Value Engineering Workshop Report

US 41 - North Main Street Kentucky Transportation Cabinet

VE No. # 202103; Item No. # 02-8305.00

Workshop Dates: August 16 - 20, 2021

TITLE Add backage roads and sidewalks in the Northwest quadrant

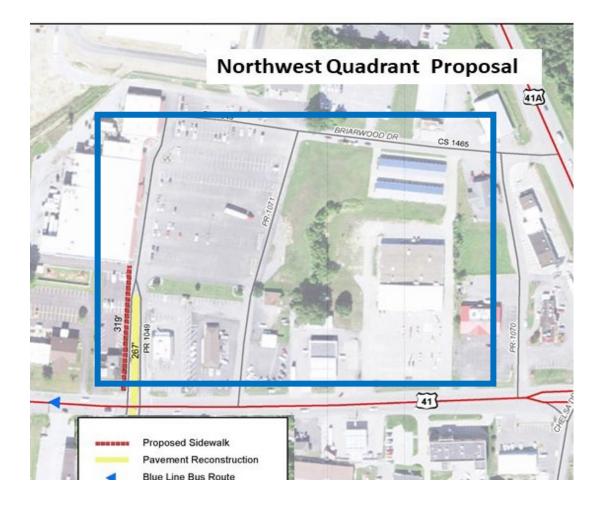
The goal of this proposal is to reduce congestion and improve safety on and from US 41 by providing improved access for all modes of travel (auto, transit, and pedestrian) through a defined and upgraded backage road system along Briarwood Drive and the private church entrance in the Northwest Quadrant of the project corridor. This includes upgrading pedestrian facilities by extending sidewalks from the US 41/Briarwood Drive intersection to the Covenant Community Church sidewalk. It is proposed to add curb and gutter on the southside of Briarwood Drive from US 41 to the church parking lot directly across from the sidewalk in front of church. Also, we propose to provide two curb openings into the Enterprise parking lot to provide defined entrances into the property and improve pedestrian connectivity.

The typical section for Briarwood Drive would be revised to include a sidewalk, however the total width will remain the same. The typical section for Briarwood Drive would be a five-foot sidewalk with a two-foot berm on either side, then a barrier header curb, with an 11-foot through lane exit and a 12-foot left turn lane exit, with 2.16-foot raised median, with a 16-foot entrance and barrier header curb with two-foot berm.

TITLE Manage US 41 direct access

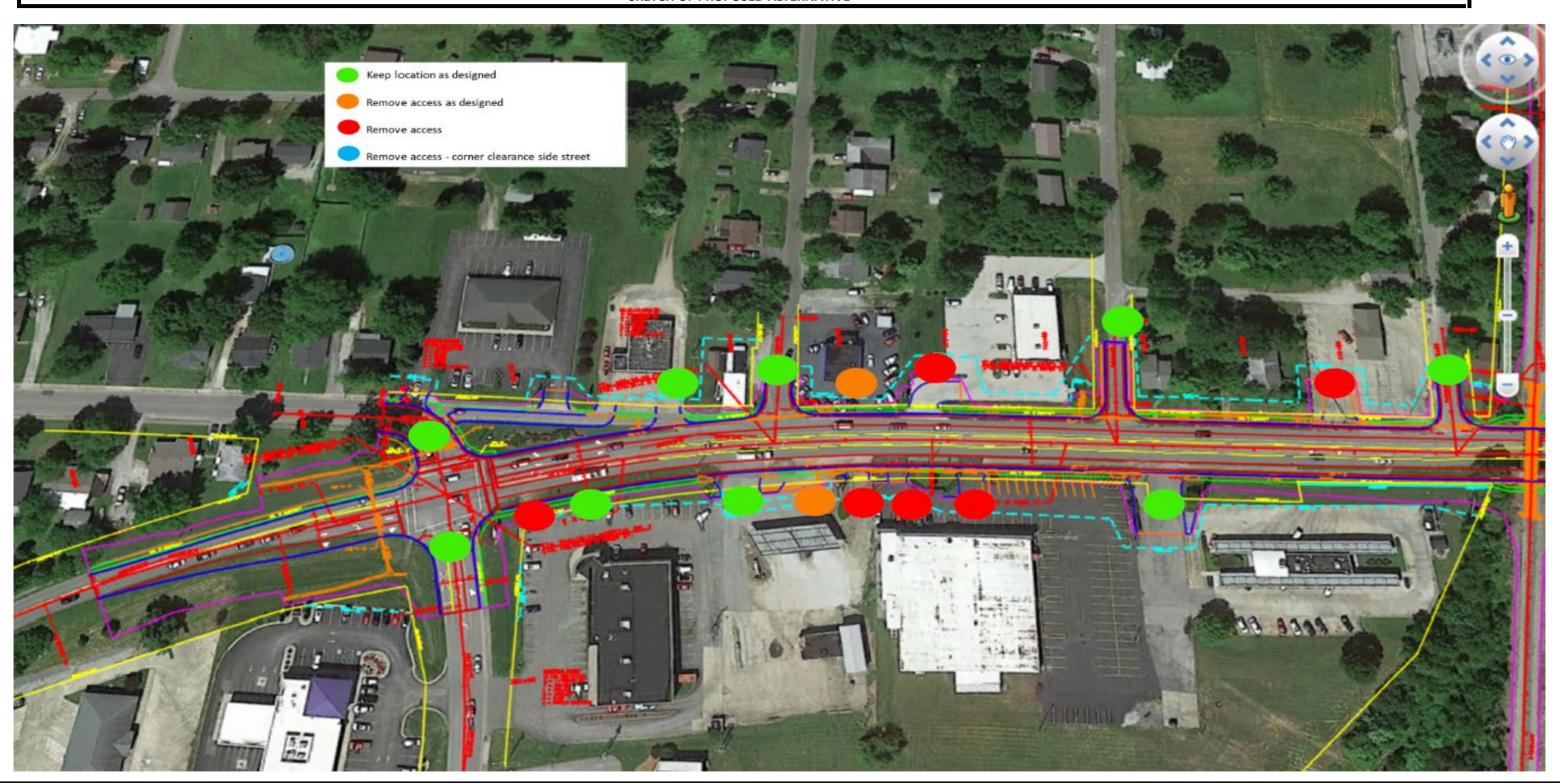
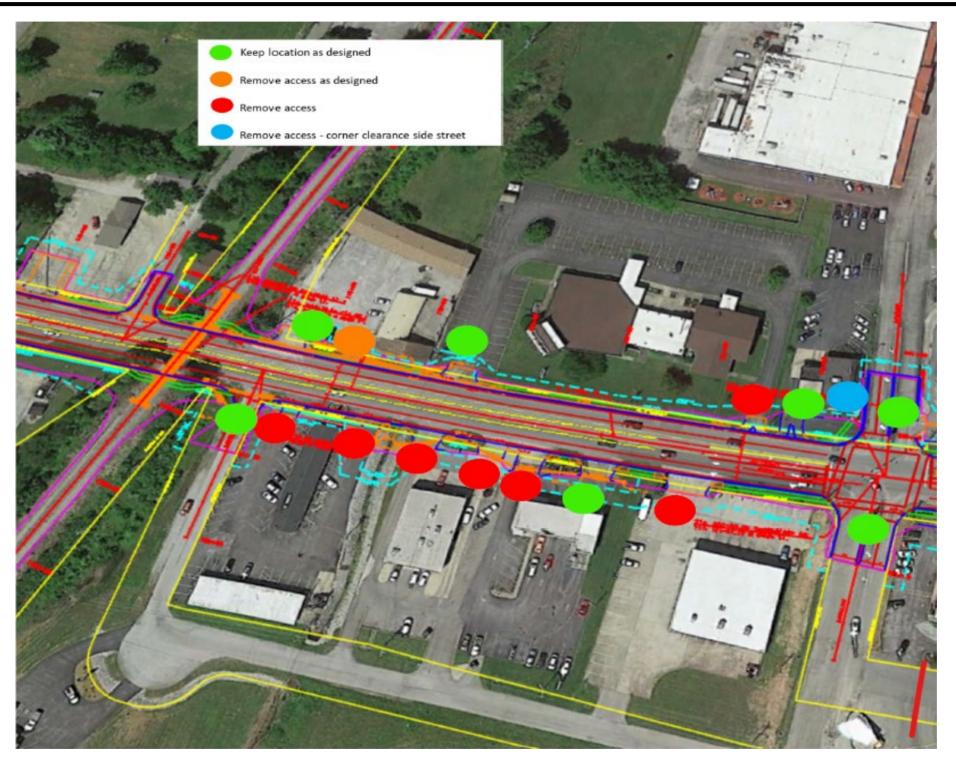
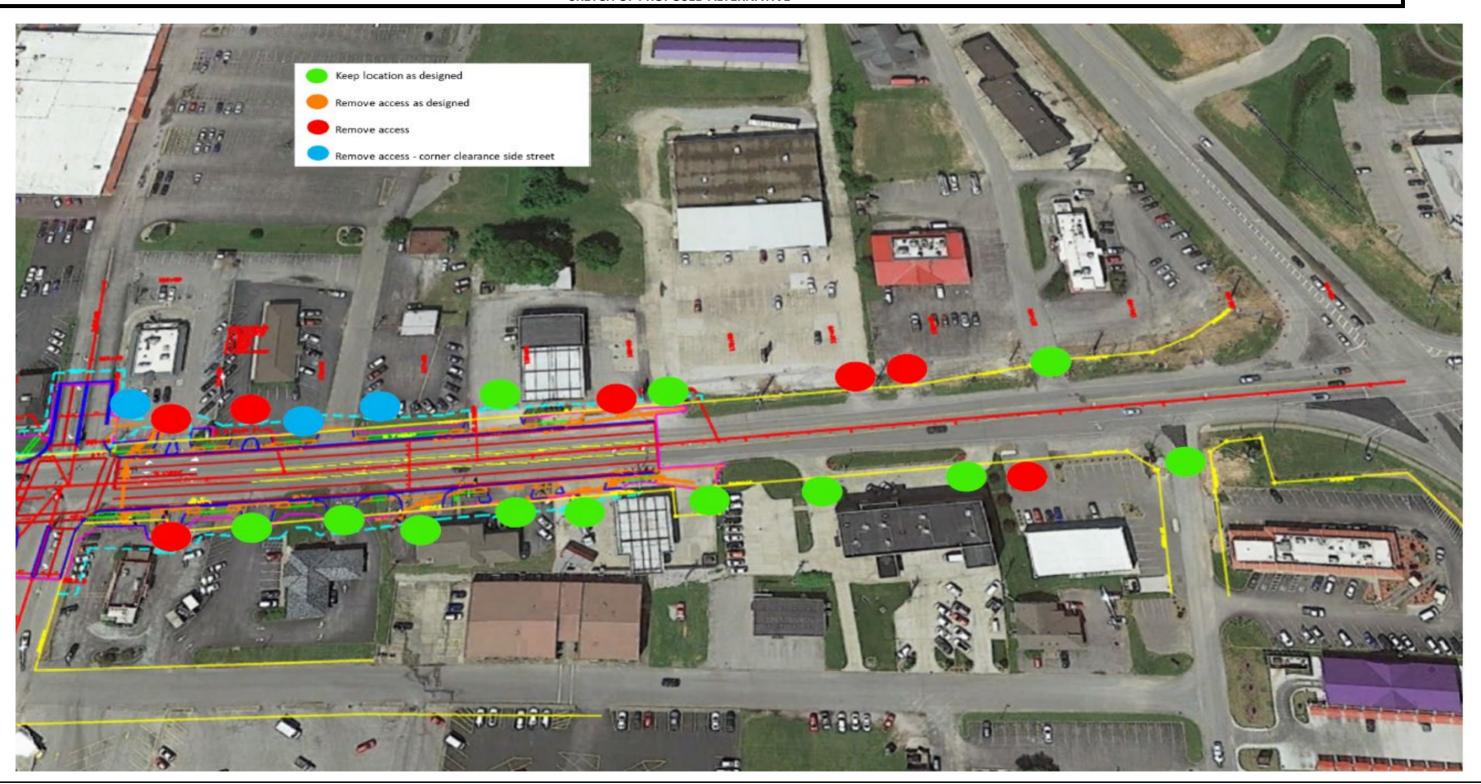
- ,			
PROPOSED ALTER	NATIVE:						
		undant access no	ints to	LIS 41 that are dunlicati	ive or where there is sufficient		
				· ·	equate corner clearance both		
	gside streets and entrand	•	es tila	t the project provide ad-	equate corner clearance both		
011 03 41 and alon	gside streets and entrant	es.					
BENEFITS			RISKS	S/CHALLENGES			
Improves tra	ffic flow		T.IOI.C	-	ntial cost to Right of Way		
			acquisition				
 Reduces con 	flict points, thus expected	d crashes	Probable resistance by property owners whose access				
	mot points, thus expected	a 0. 0000	is modified				
Better use of	f backage road system for	raccess					
Cleaner look	along the corridor						
	Ü						
Safer for ped	lestrians due to less confl	icts with turning	•				
vehicles		0

Potential Mid-block Crossing Location

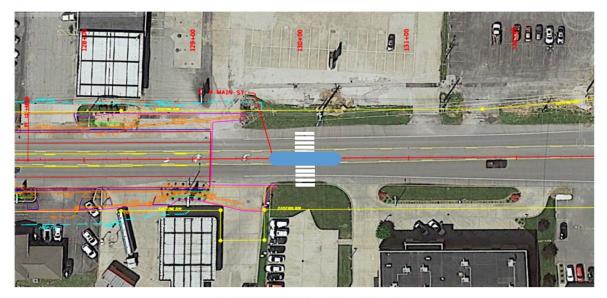
Mid-block pedestrian crossings are also recommended. Currently, the design calls for traffic signals at Hospital Drive, Briarwood Drive, and KY281 (just north of this project). These would be the only official pedestrian crossings on this section of US41. The distances between signals is 1700 and 1200. To shorten that distance, it recommended to provide midblock crossings in between signals. One potential location would be close to Railroad Street. Another would be located approximately half way between Briarwood and KY281. Constructing a refuge island or median cut-through at these locations will allow a location protected from moving vehicles and allowing peds to cross one direction of traffic at a time.

TITLE Alternative 5 – Construct design alternative #2 with modifications

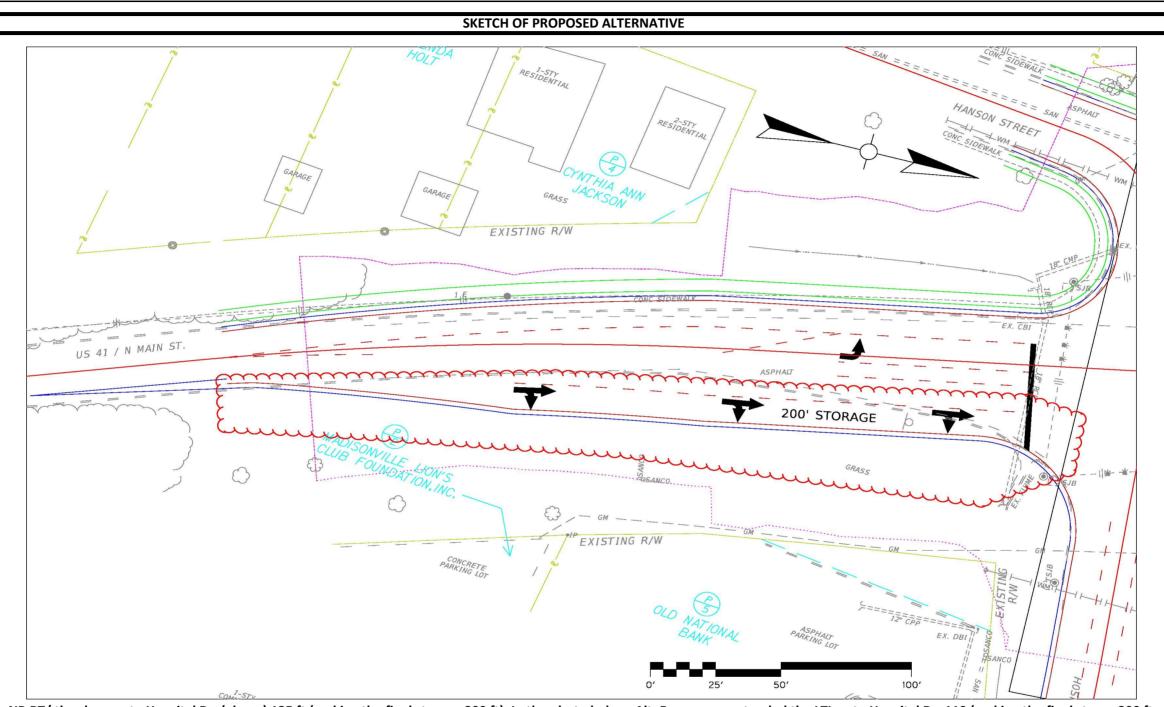
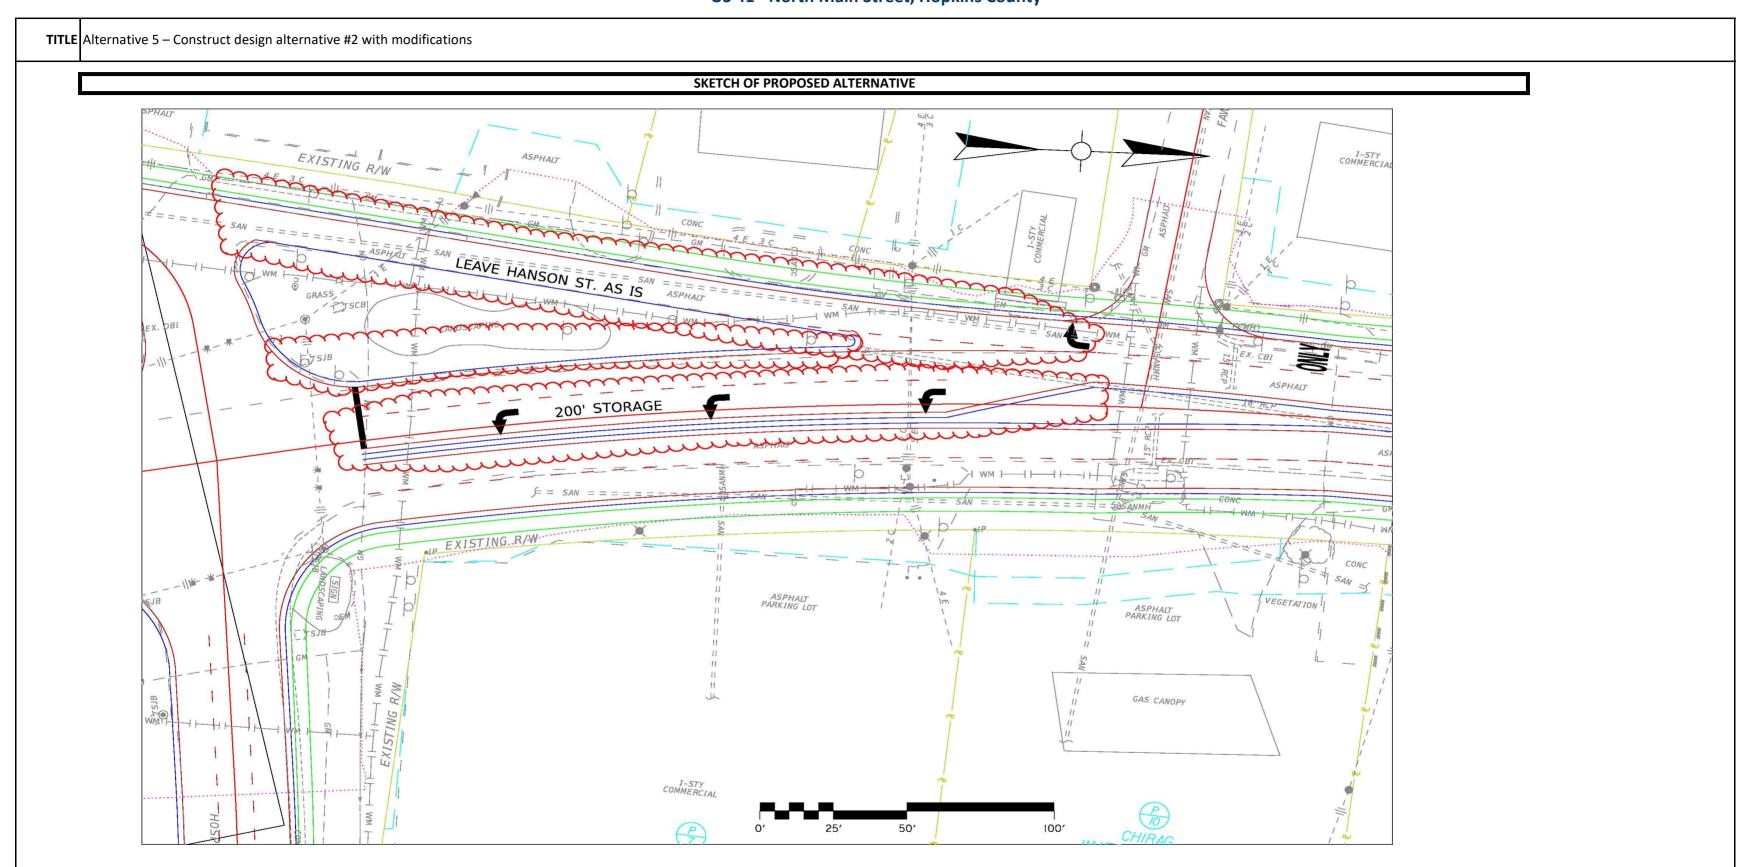
TITLE Alternative 5 – Construct design alternative #2 with modifications
DISCUSSION/JUSTIFICATION:
MA-27 - Traffic data shows that approximately 30% of the cars per day uses the Hanson Street (one-way) path towards town. Keeping this path open eliminates the need for the right turn onto Hanson Street from Hospital Drive.
M-01 - The main span is 70 feet long. (Including the sidewalks, makes the span 90 feet. This means that a bigger (taller) beam is needed to clear the width.) Having a median in the middle with two spans means 45-foot sections containing two lanes in one direction and a sidewalk (providing a buffer between the pedestrians and traffic). Lanes are 11 feet wide each. (See the Proposed Sketch.)
RC- 15 - While the 75 feet of storage for the RTL design meets the need, the through lane will block access to the right turn. While this Alternative will have a similar safety performance to Alternative. 2, compared to the baseline, Alternative 1, this Alternative estimates a 20% reduction in total crashes per year with a 15.67 crashes per year. The proposed 200-foot storage will allow adequate length to access the turn lane when the through lane is queued up, subsequently this will improve emergency response times to the Baptist Health Hospital. The extended lane provides better performance in the queue length based on traffic analyses. (See Proposed Sketch)

RC-23 - While 30 ft of storage for the LTL design meets the need, the through lane will block access to the left turn; therefore, the proposed 200-foot storage will allow adequate space to move into the turn lane and subsequently improve emergency response times to the Baptist Health Hospital. (See Proposed Sketch)
SPECIAL IMPLEMENTATION CONSIDERATIONS:
Additional coordination needed with CSX to review and approve new bridge concept.

Alt. 5 proposes the extension of the NB RT/ thru lane onto Hospital Dr. (above) 125 ft (making the final storage 200 ft). In the photo below, Alt. 5 proposes extended the LTL onto Hospital Dr. 110 (making the final storage 200 ft as well). Alt. 5 proposes to leave Hanson Street open (using it as a lane-drop location for the right lane (SB on US 41). This eliminates the need for the SB RTL at Hospital Dr as in the baseline.

TITLE Replace signals with roundabouts and use quick-curb between intersections

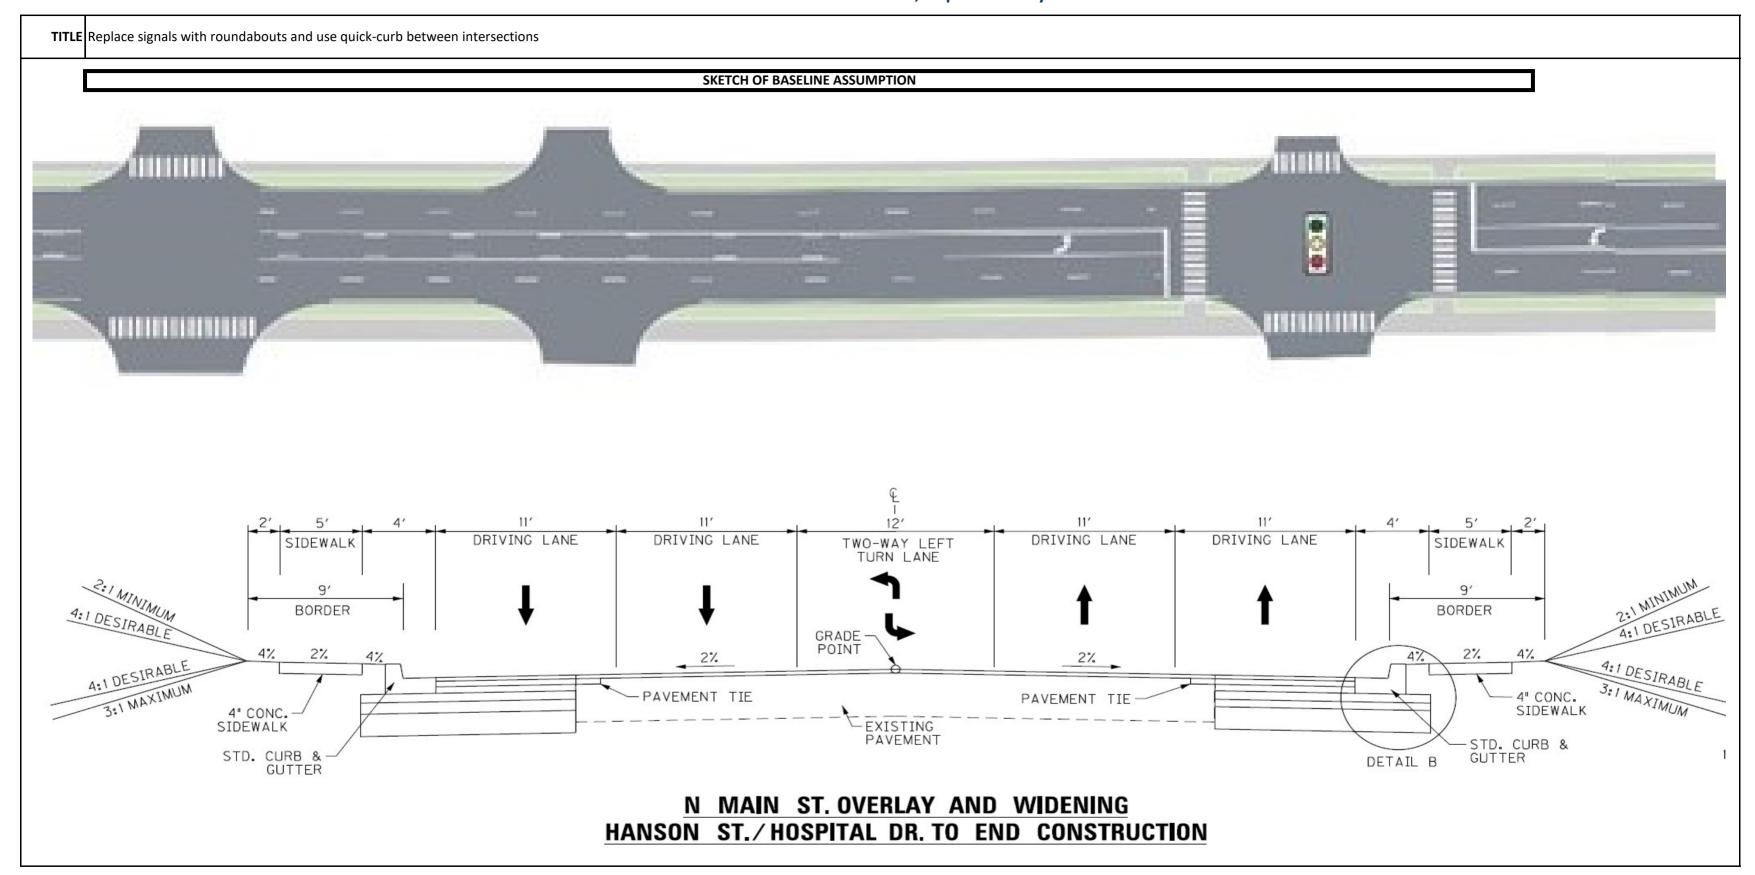
TITLE Replace signals v	vith roundabouts and use quick-curb between intersections
DISCUSSION/JUSTIFICATION:	
This proposal, unlike Alternative 4, congestion and reduce conflicts. Th backage road circulation improvem	would be a relatively minimalistic design approach to this project in order to reduce is approach to the project will not include sidewalks, railroad bridge replacement, or ents. It is entirely focused on the two main problems US 41 is experiencing; a high eft turns and long roadway queues due to single lane intersection capacity, using
centerline quick-curb would not be support U-turns of larger vehicles, v	ing. Each roundabout can be designed and constructed separately, if desirable. The installed until both roundabouts were available to support U-turns. Roundabouts whereas the proposed loons only accommodate passenger vehicles. This alternative the US 41 roadway to 2 lanes with median and accommodating pedestrians at a
